400 Chestnut Street Tower II

October 2, 1979

Enclosed are responses to Reactor Systems Branch questions (items 212.104 through 212.114) on Loss of Coolant Accidents (LOCA) transmitted by your letter to H. G. Parris dated August 21, 1979. These responses will be incorporated into the Sequoyah Nuclear Plant Final Safety Analysis Report by Amendment 62.

RESPONSES TO REACTOR SYSTEMS BRANCH QUESTIONS

Figure 15.2-10 Effect of Reactivity Insertion Rate on Minimum DNBR for Rod Withdrawal Accident from 10% Power

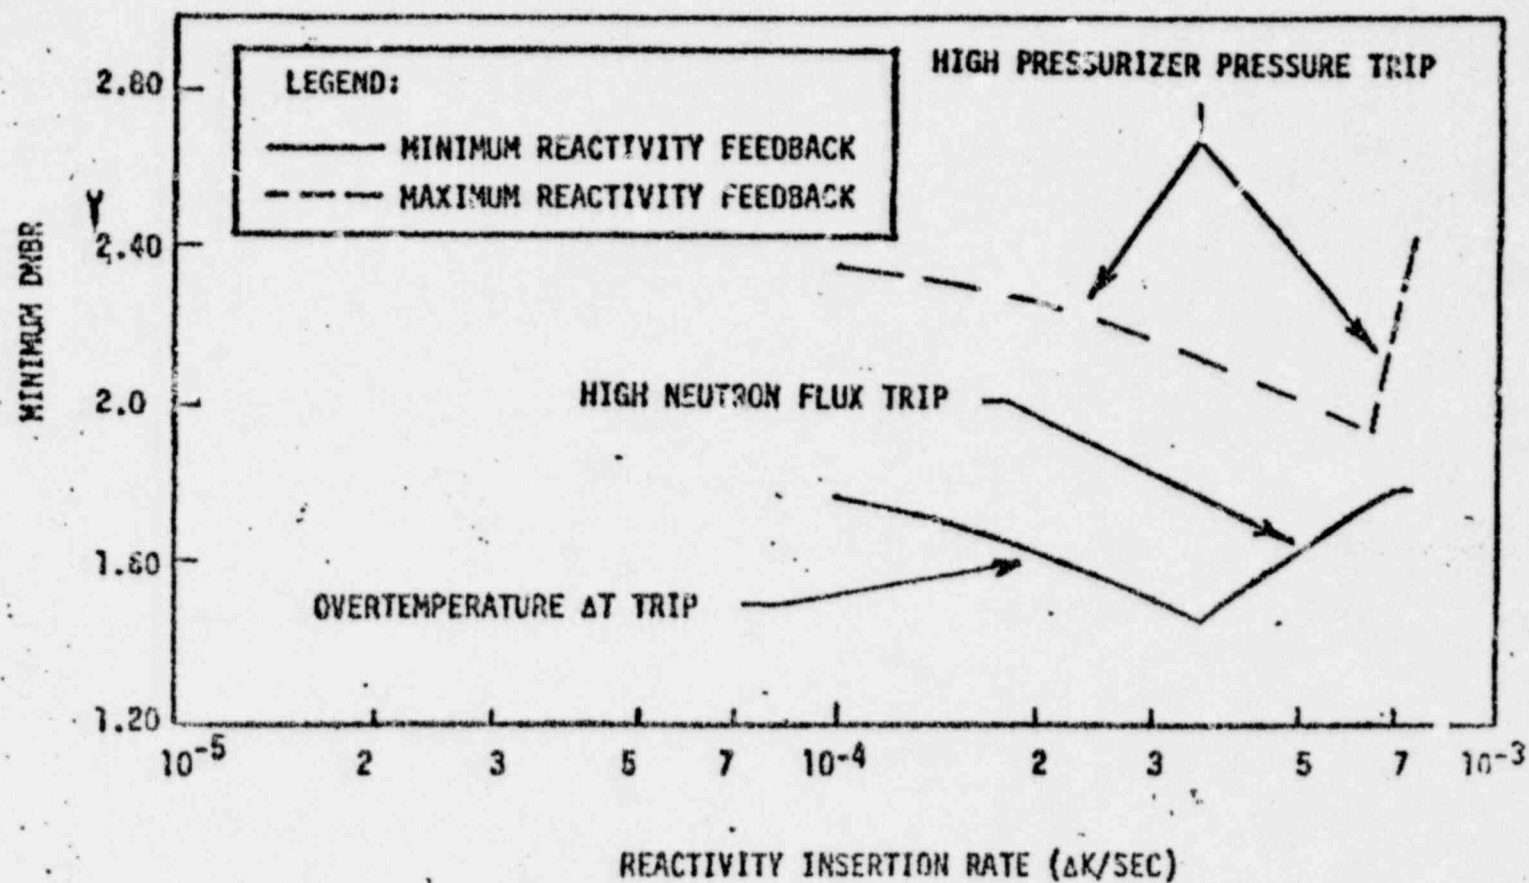
- (212.106) The response to Q15.26 has discussed temperature measurement and modifications to Sequoyah reactor internals that would increase bypass flow to assure that 4 percent of the total cold leg flow would enter the upperhead region to maintain the upperhead region temperature at the cold leg value. The response has not addressed concerns about the impact of this increased bypass flow on Chapter 15 analyses. Please address this concern.

An increase in core bypass flow affects the overtemperature  $\Delta T$  protection setpoint calculation. The appropriate setpoint and Tech Spec revisions have been made. The overtemperature  $\Delta T$  trip is required for protection during transients which approach DNB. This trip is most important during the slow rod withdrawal at power event.

The rod withdrawal at power accident has therefore been reanalyzed, using the adjusted overtemperature  $\Delta T$  setpoints. The conclusions drawn in the FSAR are unchanged for this new analysis (i.e. the DNBR does not fall below 1.30). Appropriate revisions have been made to Section 15.2 to reflect this new analysis.
